**Fraser Planning Commission Agenda
City Council Chambers
33000 Garfield, Fraser, MI 48026
Wednesday, December 4, 2024 @ 7:00 p.m.**

Site Plan Review Summary

Site Plan Dated 11/01/2024
City of Fraser, Michigan

The site plans were updated in accordance with the review comments from McKENNA (October 7, 2024) and from Anderson, Eckstein & Westrick, Inc. (AEW) (October 29, 2024) provided as part of the planning commission agenda packet. The comments and responses are summarized below to the items that were identified requiring a response or revision. Items noted to be compliant may not be referenced in this letter.

MISTER CAR WASH
STORE # MI 1454 FRASER
SITE PLANS
PRELIMINARY UTILITY PLAN

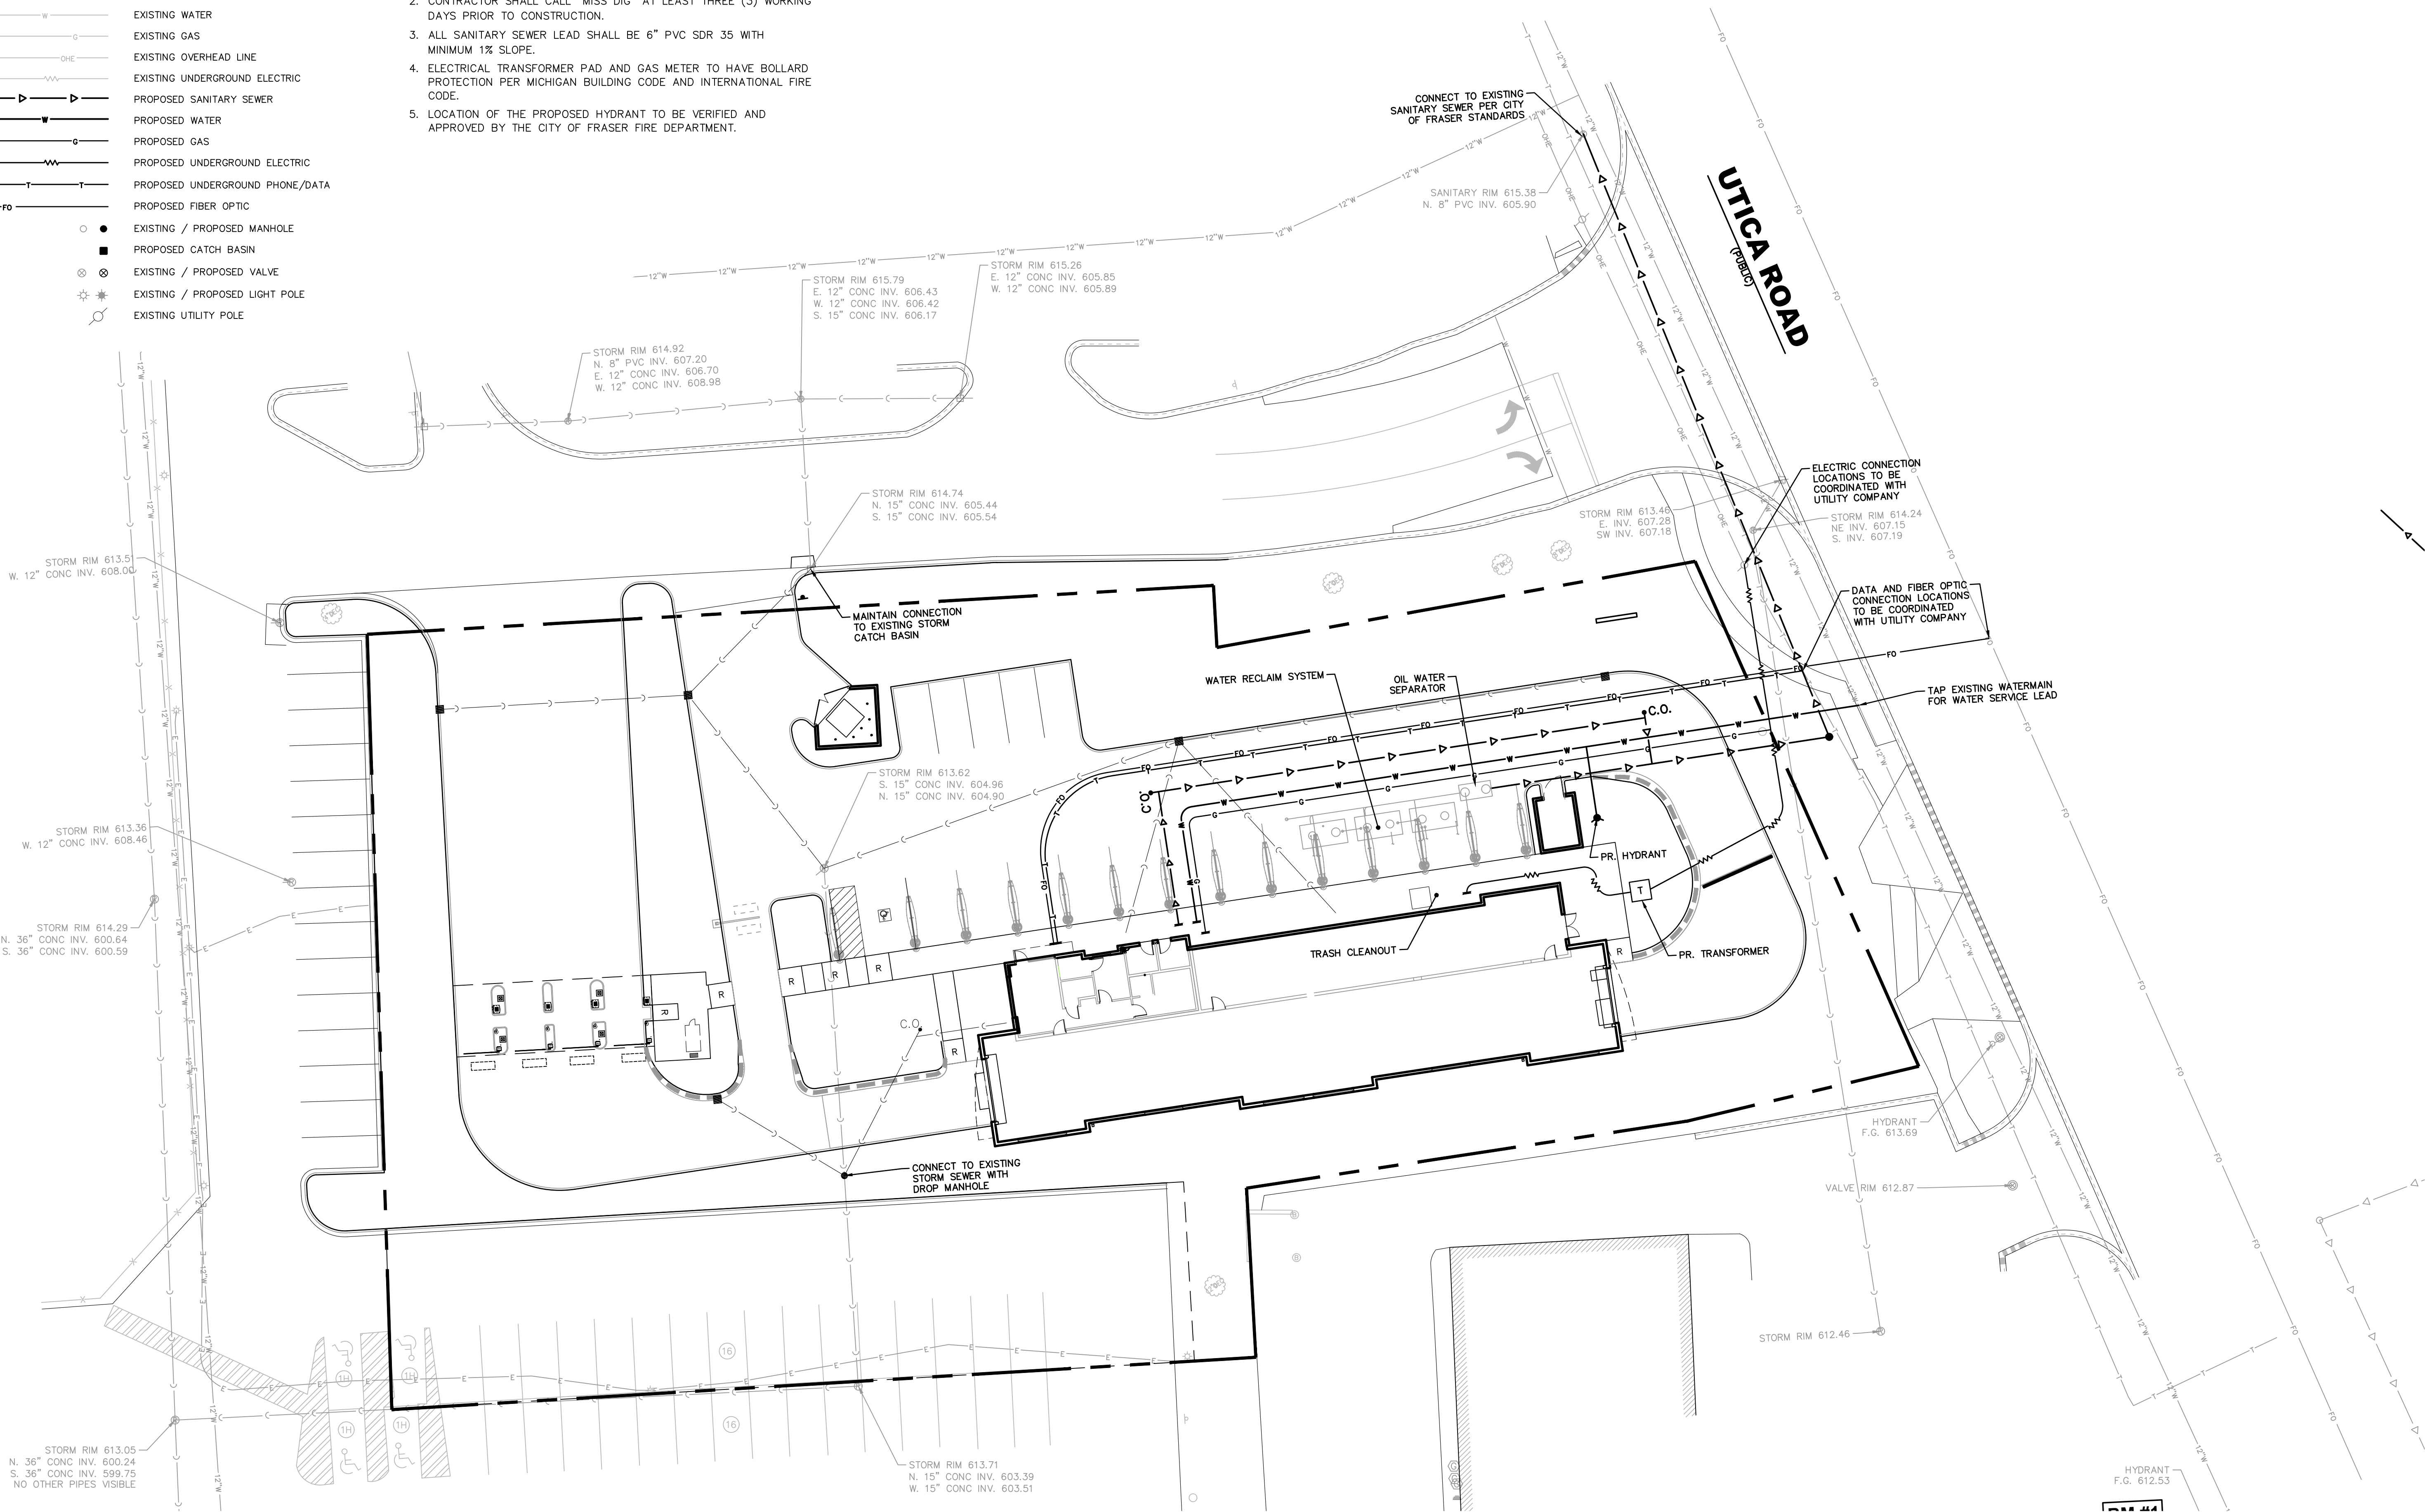
1. An existing 12" water main is located under the southbound lanes Utica Road and is available for service to the site. Site plan should be updated to reflect correct location. **RESPONSE:** Noted

2. There is currently no sanitary sewer along the frontage of this property. Sanitary sewer will need to be extended across the frontage of the proposed outlot to a point inside the northerly property line. It is not anticipated that future sewer extension will be necessary to the south as all parcels south currently have access to public sewer. **RESPONSE:** Noted

3. Storm sewer is currently available on the proposed outlot site as part of the overall Meijer drainage system. This system can be utilized by the developer with appropriate maintenance agreements and easements as may be required. **RESPONSE:** Noted

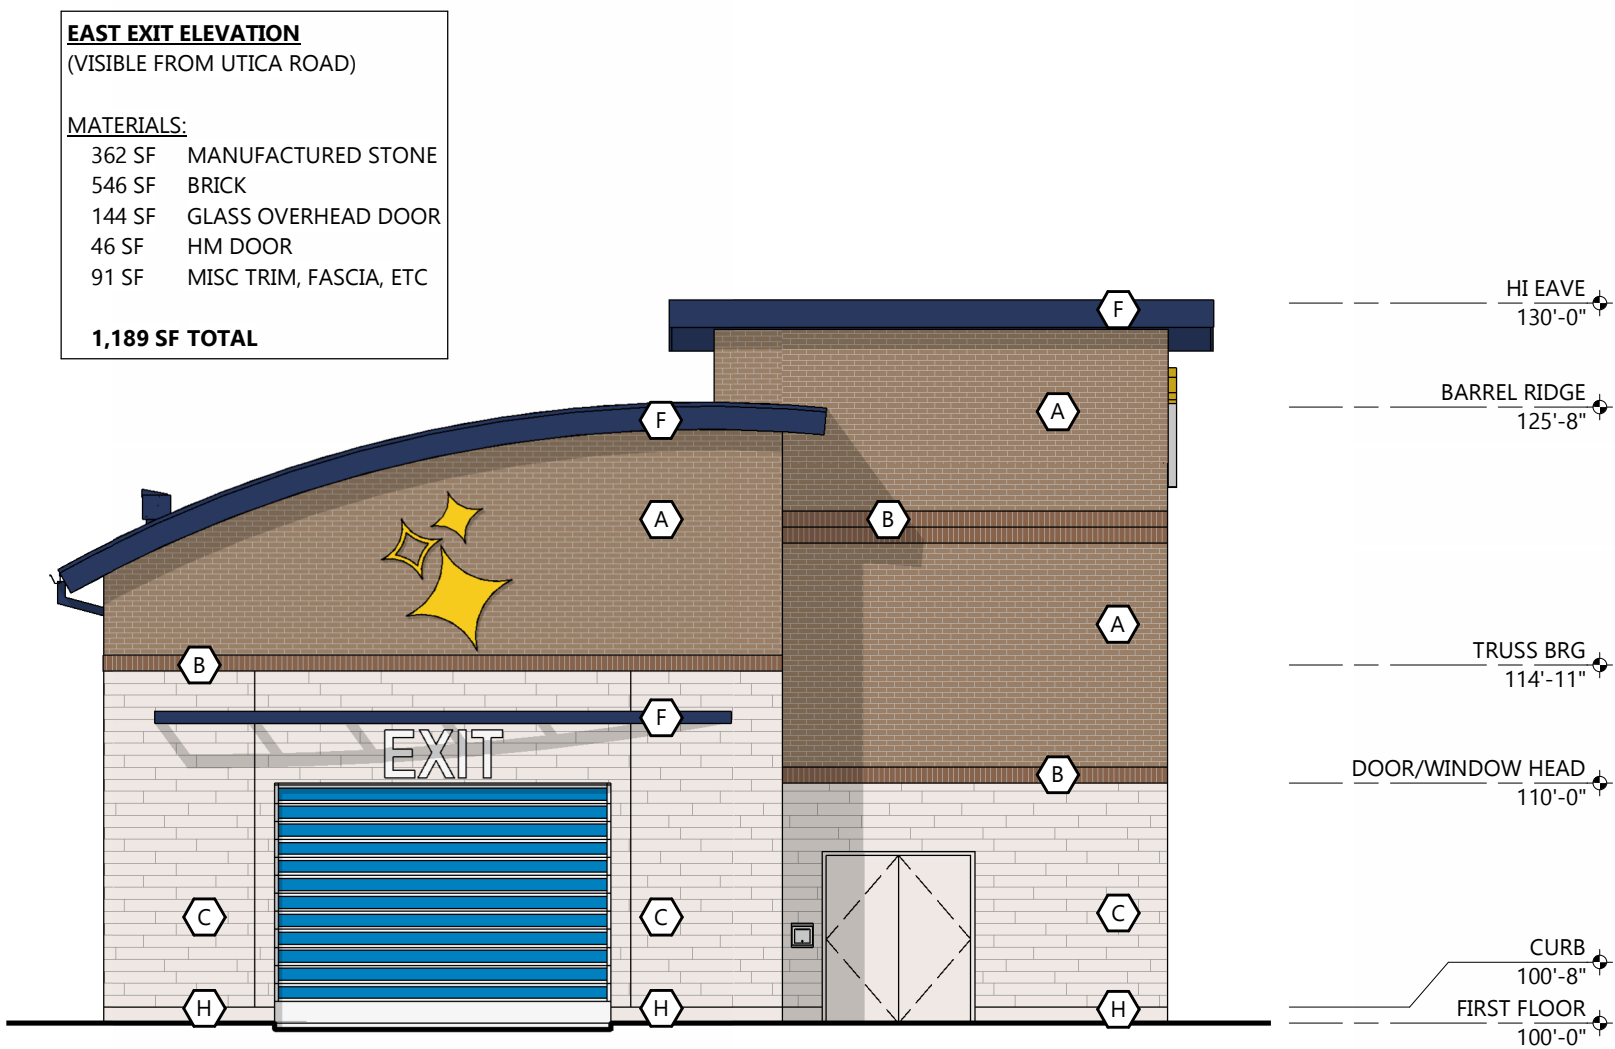
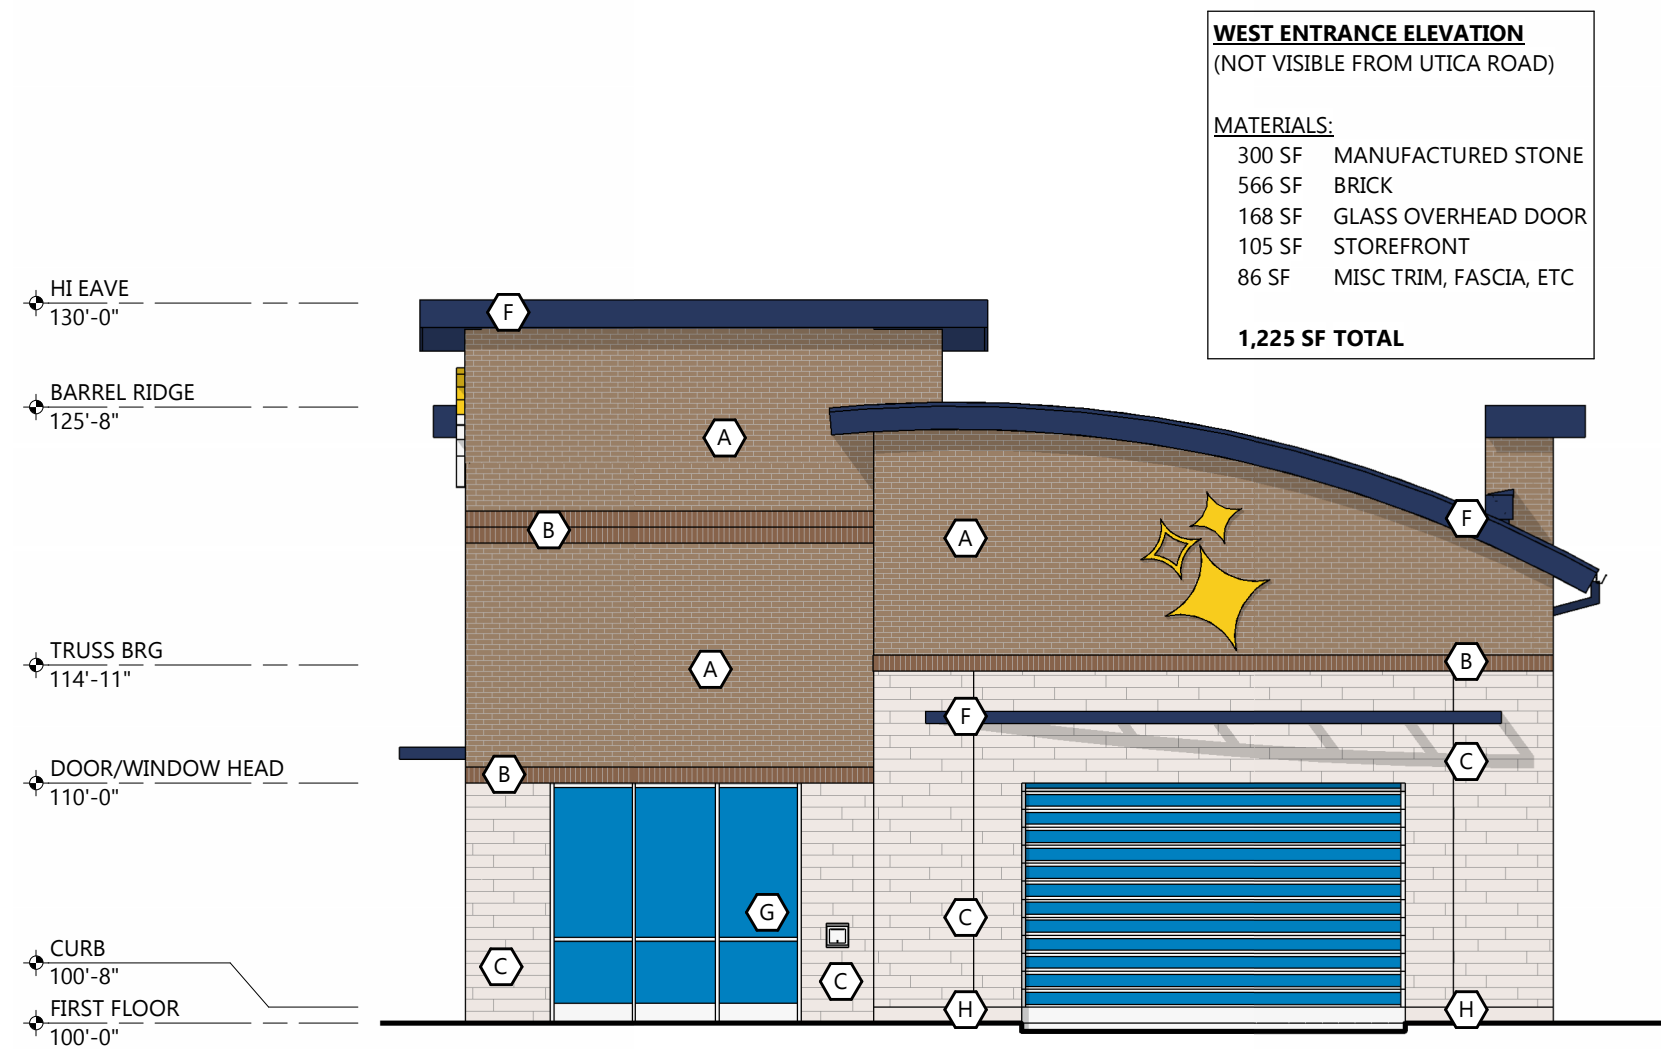
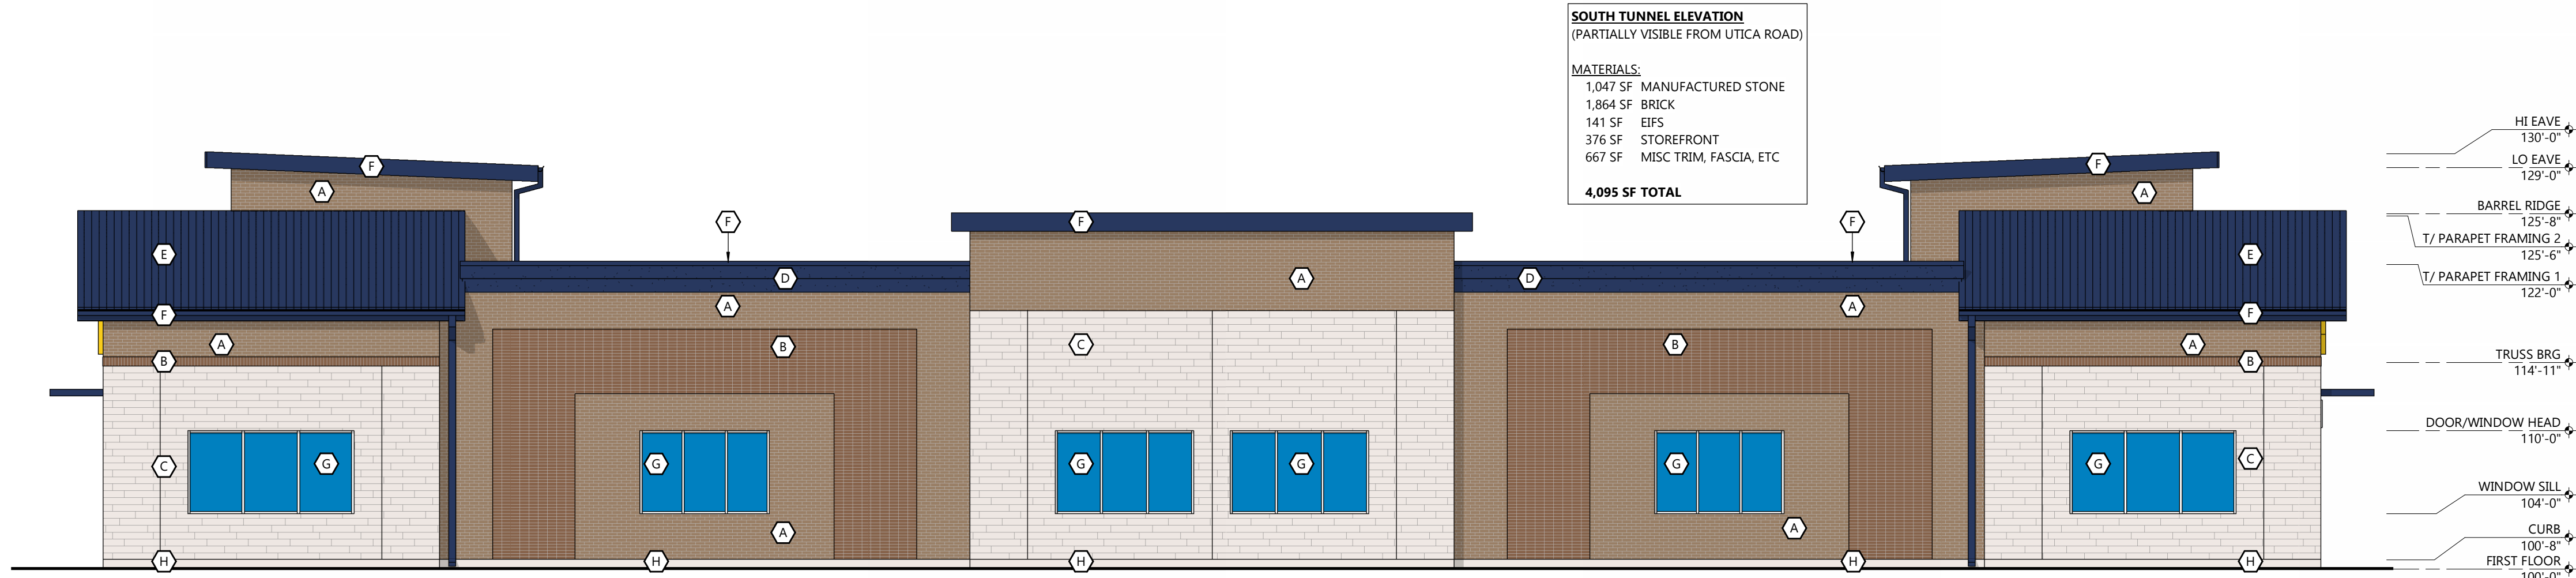
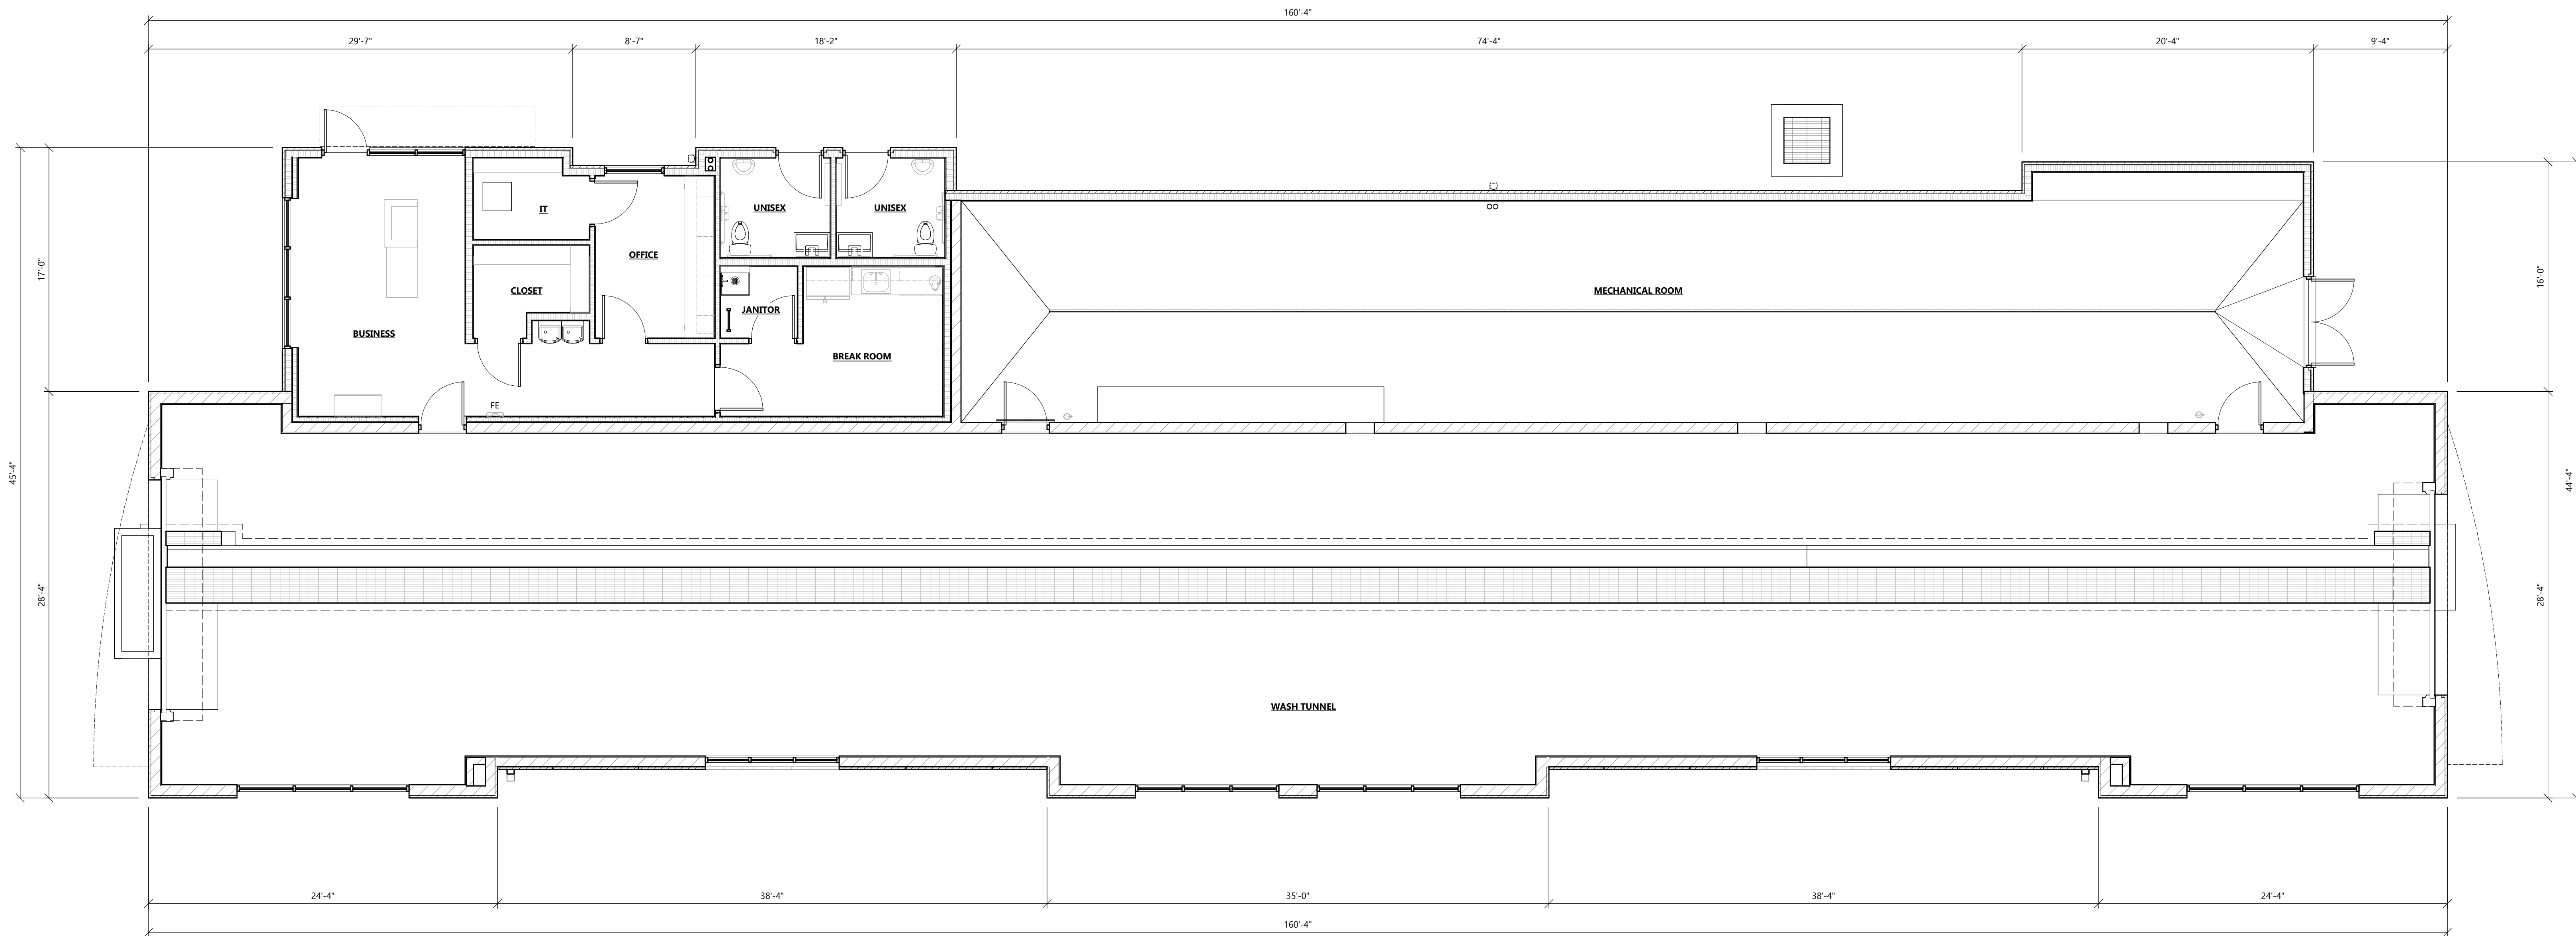
****Note the site plan elevations on Sheet PRE-1 indicate the building is 135 feet tall. We believe this to be an error and an extra "1" was added to each height based upon the seemingly correct elevation for the West Entrance. Given this we assume the proposed height is 35 feet, which exceeds the required height permitted.** RESPONSE: Architecture typically sets their base elevation at 100 while civil sets there's at 0. Consequently, an architectural elevation of 100 is actually 0 and architectural elevation 135 is actually 35'. Height adjusted accordingly to 30' and is represented in the updated elevations.
